GARY R. PETERSON
Vice President
McGuire Nuclear Station

Subject: Duke Power Company LLC d/b/a
Duke Energy Carolinas, LLC
McGuire Nuclear Station, Units 1 and 2
Docket Nos. 50-369 and 50-370

License Amendment Request for Technical
Specification 3.6.3, Containment Isolation Valves,
and Technical Specification 3.3.6, Containment
Purge and Exhaust Isolation Instrumentation

MARKED PAGES OF AFFECTED TECHNICAL SPECIFICATION

3.6.3 Containment Isolation Valves

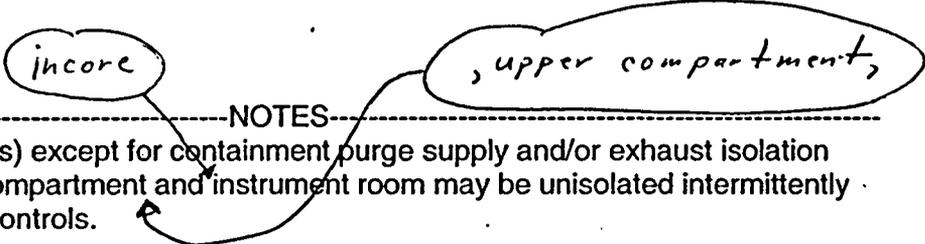
- 1) Note 1 under ACTIONS will be revised by adding "upper compartment" as an additional penetration restriction.
- 2) Surveillance Requirement (SR) 3.6.3.1 will be revised to include the upper compartment supply and exhaust purge valves from SR 3.6.3.2. The Surveillance Requirements for the upper and lower purge valves will be identical after this change.
- 3) SR 3.6.3.2 will be deleted since this SR for the upper compartment purge valves will become identical to SR 3.6.3.1.

- 4) Replace "instrument room" with "incore instrument room" in ACTIONS, SR 3.6.3.1, and SR 3.6.3.6 to be consistent with the UFSAR and Design Basis Documents.
